**HUDSON RIVER PCBs REASSESSMENT RI/FS
RESPONSIVENESS SUMMARY FOR
VOLUME 2C-A LOW RESOLUTION SEDIMENT CORING REPORT
ADDENDUM TO THE DATA EVALUATION AND INTERPRETATION REPORT**

The U.S. Environmental Protection Agency (EPA) is pleased to release this Responsiveness Summary to the Low Resolution Sediment Coring Report (LRC) for the Hudson River PCBs Superfund site. This document contains written comments from various reviewers of the LRC and the Agency's responses to significant comments. In addition, the appendices to the responsiveness summary include: a comparison of sediment PCB inventory between 1984 and 1994 on an area basis, rather than a point-to-point basis; a revised estimate of the Thompson Island Pool sediment PCB inventory; and, a revised estimate of the loads measured in EPA's 1993 water-column sampling based on corrections to the site database described in the December 1998 Responsiveness Summary for the Database Report, Preliminary Model Calibration Report, and Data Evaluation and Interpretation Report.

**HUDSON RIVER PCBs REASSESSMENT RI/FS
RESPONSIVENESS SUMMARY FOR
Volume 2C-A LOW RESOLUTION SEDIMENT CORING REPORT
Addendum to the Data Evaluation and Interpretatio

Figure 2-4 (corrected)
Distribution of Total PCB Concentrations in Low Resolution Sediment Core Samples

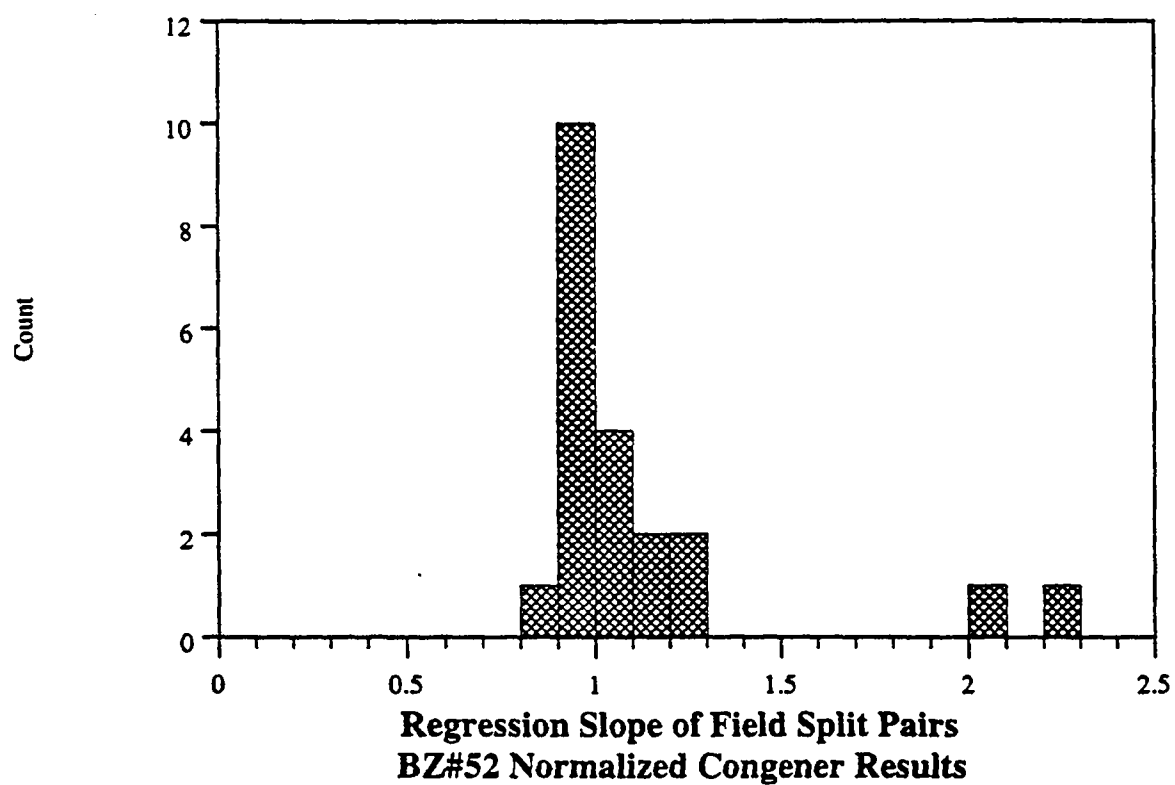
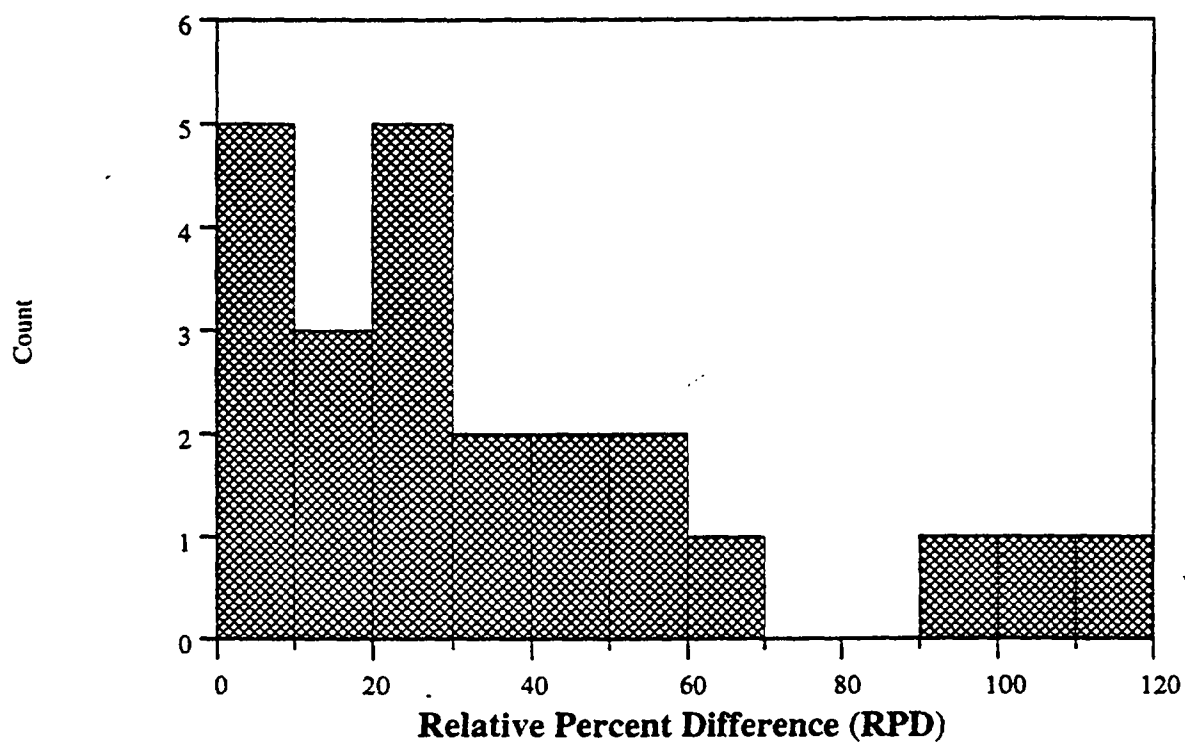
Figure 2-6 is incorrectly referenced as Figure 2-4 on page 2-18. The text of the second full paragraph on page 2-18 should read:

The units on Figure 2-4 were corrected to read mg/kg in the revised figure. The values of the abscissa of the upper figure in Figure 2-6 are corrected in the revised Figure 2-6, included in this Report.

Figure LF-1.3A
Depth Difference of PCB Maximum and the First Appearance
of Wood Chips in All Low Resolution Core Samples

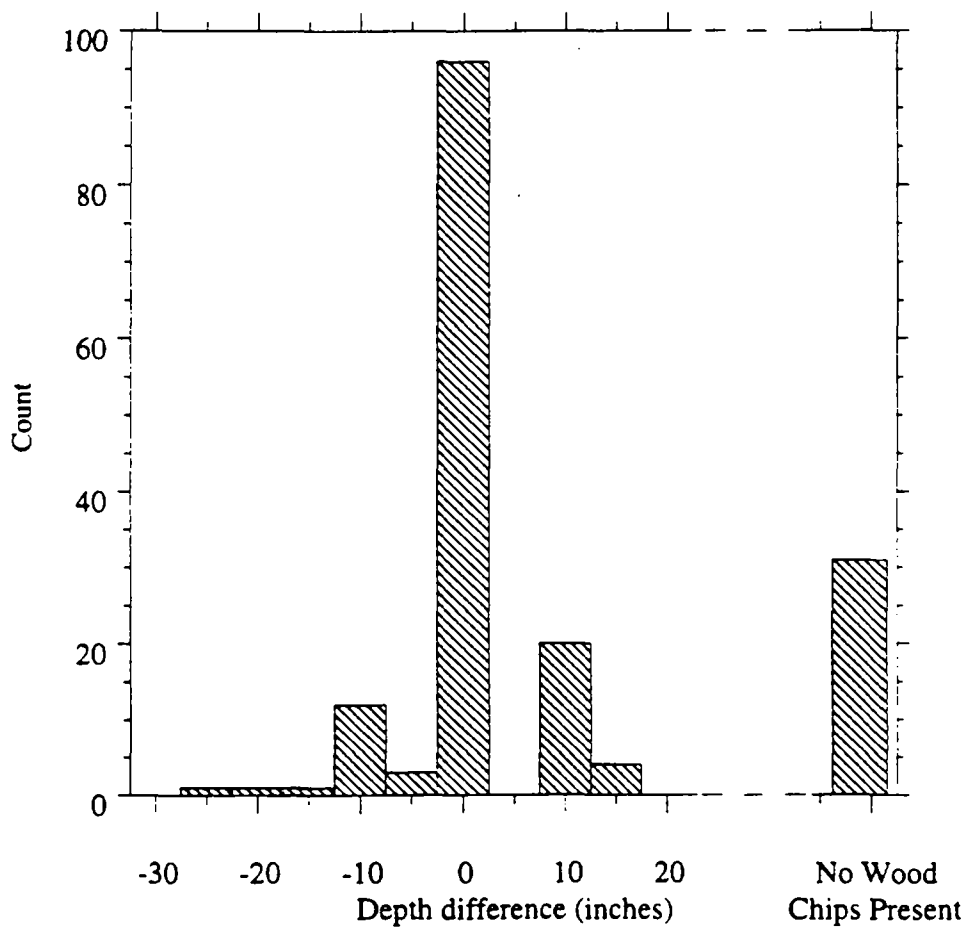
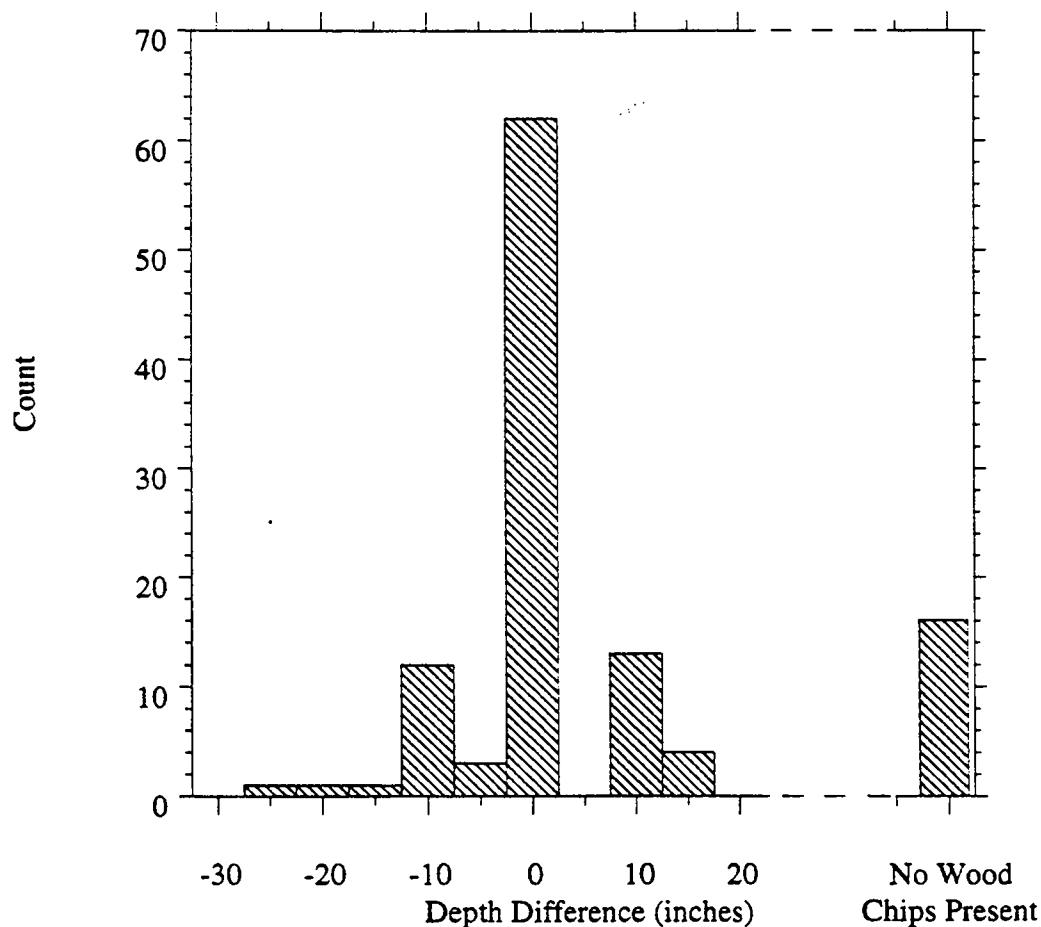
Response to LF-1.3

In response to this comment USEPA has prepared a further analysis of the wood chip and PCB data available for the low resolution cores. The field geologist's descriptions concerning the absence or presence of wood chips were retrieved from the database and correlated with the occurrence of the PCB maximum. This was accomplished by subtracting the upper depth of the core segment containing the PCB maximum from the upper depth of the first core segment found to contain wood chips. Thus core segments with coincident wood chips and PCB maxima were assigned a value of zero. If the PCB maximum overlay the wood chip occurrence, a negative value was obtained. If the converse was true, a positive value was obtained. The results for all low resolution cores are presented in Figure LF-1.3A. It is clear from this figure that the PCB maximum and the appearance of wood chips are coincident (difference equal to 0) in the majority of the low resolution cores, given their coarse resolution. The next largest group is those cores where wood chips were not reported. The next most important groups are those occurring at about 10 inches separation, close to the typical slice thickness. However, these non-zero difference cores scatter relatively equally about the value of 0, indicating no definitive trend. These results are consistent with the conclusion based on the C/N ratio in the LRC, that is, woody materials are present throughout Upper Hudson sediments and do not reliably predict the C/N ratio.

This issue was explored further by removing those cores which might affect the distribution due to their special conditions, *i.e.*, one segment cores (one PCB analysis) and incomplete core (cores where the PCB maximum depth is uncertain). These results are presented in Figure LF-1.3B. The relationships are the same as noted in Figure LF-1.3A.

Figure LG-1.26A
The Relationship Between the Number of Chlorines per Biphenyl
and the Molar Dechlorination Product Ratio for the High Resolution Core Data

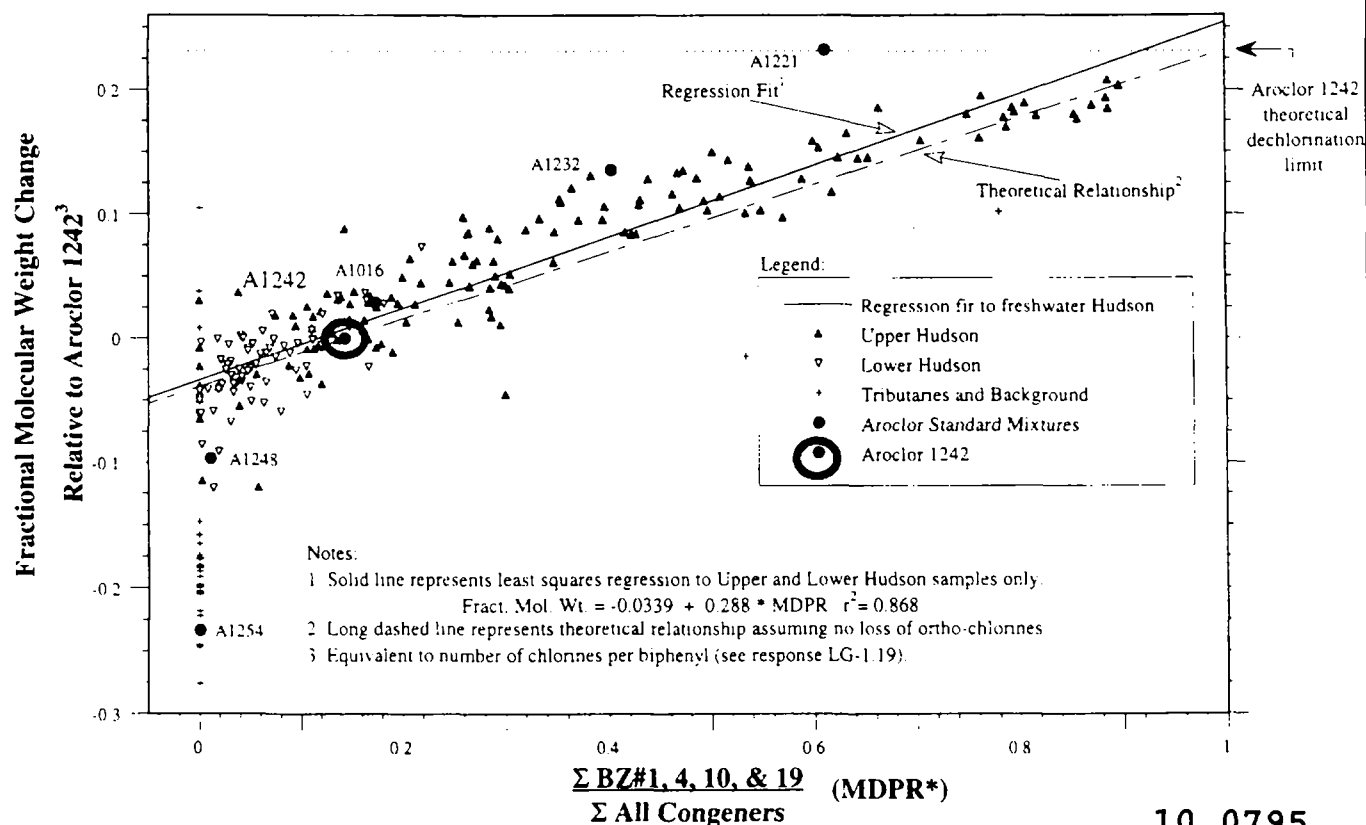
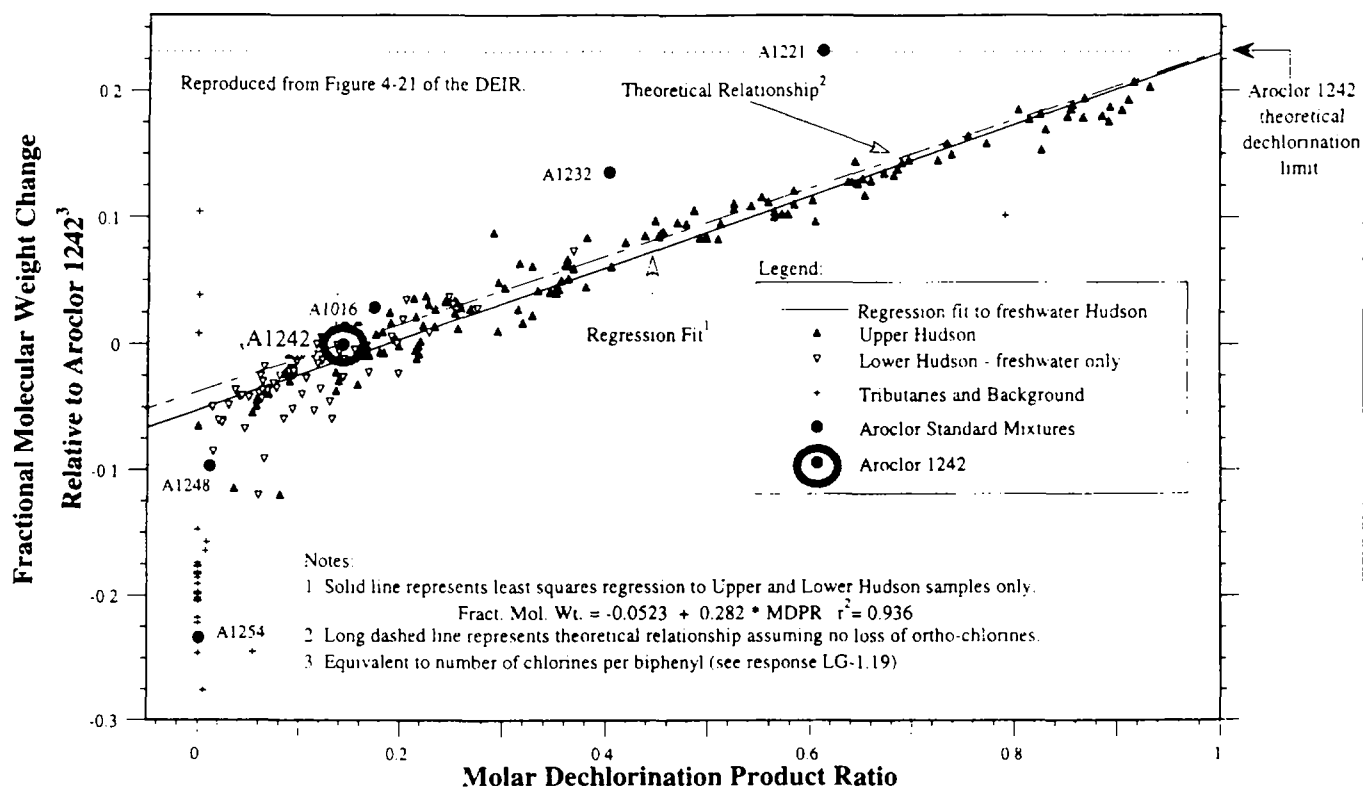
Response to LG-1.26

It has been demonstrated that the change in molecular weight (ΔMW) is algebraically related to the number of chlorines per biphenyl (Cl/BP) (*see* response DG-1.19 of the Responsiveness Summary for Volumes 2A, 2B and 2C). It has also been shown in both the DEIR and the LRC that the relationship between the ΔMW and the molar dechlorination product ratio (MDPR) is linear ($R^2 = 0.90$ or higher), meaning that the dechlorination products are produced in direct proportion to the degree of chlorine mass loss from a sediment mixture. Therefore, since these measures track each other and are directly related to Cl/BP, they directly reflect the degree of dechlorination in a sample. The quality of these measures can be contrasted with the relationship between Cl/BP and the ratios proposed by GE. This is illustrated by comparing Figure LG-1.21 and Figure LG-1.26A. The ratios proposed by the writer yield R^2 values of 0.4 or less, indicating the substantially greater scatter and therefore reduced sensitivity in these relationships. In particular note the broad ratio ranges seen around 2.5 to 3 Cl/BP, levels commonly found in the Hudson.

The discussion concerning the insensitivity of the MDPR to the conversion of BZ#8 (2,4'-dichlorobiphenyl) to BZ#1 is misleading. This conversion is only important at extremely high degrees of dechlorination. At levels more typical of Hudson sediments, BZ#8 forms an important intermediate whose inclusion in the MDPR enhances the usefulness of this ratio. This is illustrated in Figure LG-1.26B which compares the MDPR and MDPR*. MDPR* is defined as the sum of BZ#1, 4, 10 and 19 (excluding BZ#8) over the sum of all congeners on a molar basis. Figure LG-1.26B shows that the MDPR* also tracks the change in molecular weight although not as well as the original MDPR. However, both ratios are clearly superior to the ratios proposed by the writer.

Figure 4-10 (corrected)
Distribution of the Percent Change in
PCB Molar Inventory (Δ_M)

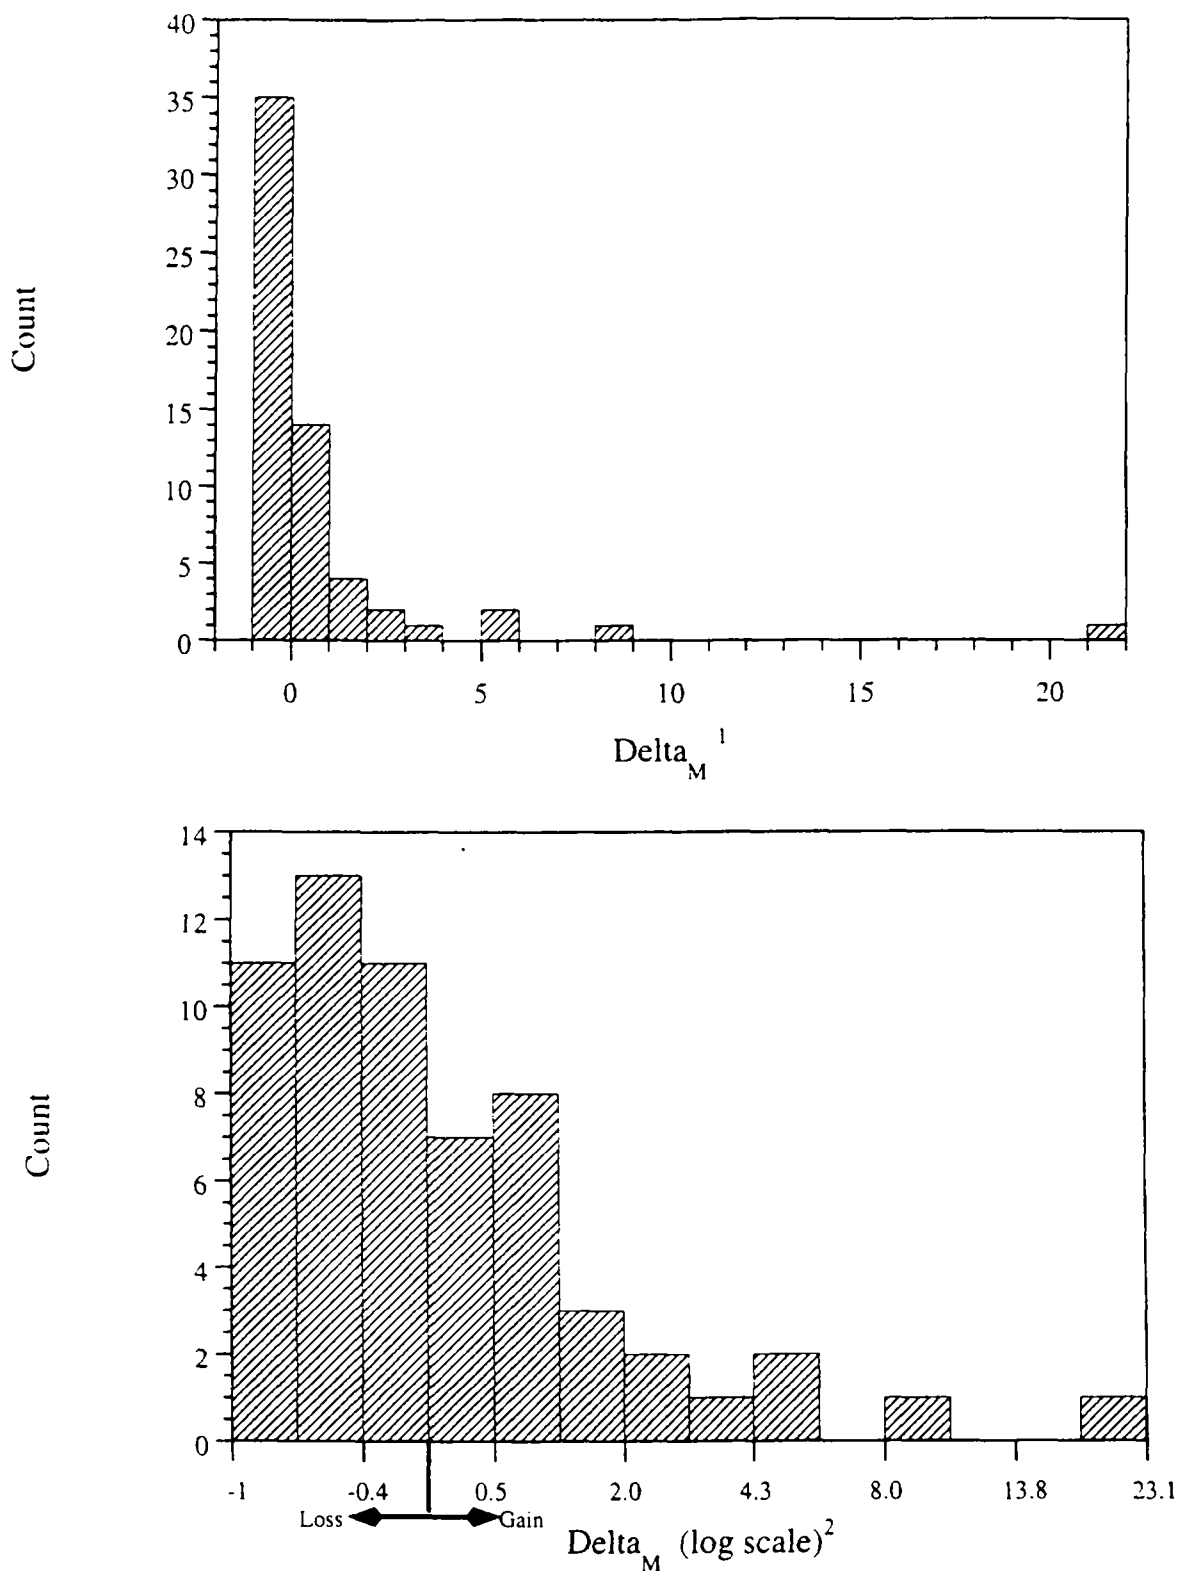
USEPA acknowledges the error in this LRC figure. This correction has been noted in the Corrections to Section 4.1.1 of the Low Resolution Sediment Coring Report.

The x axis on the lower diagram in Figure 4-10 was corrected to show the correct values and units. It is included in this report.
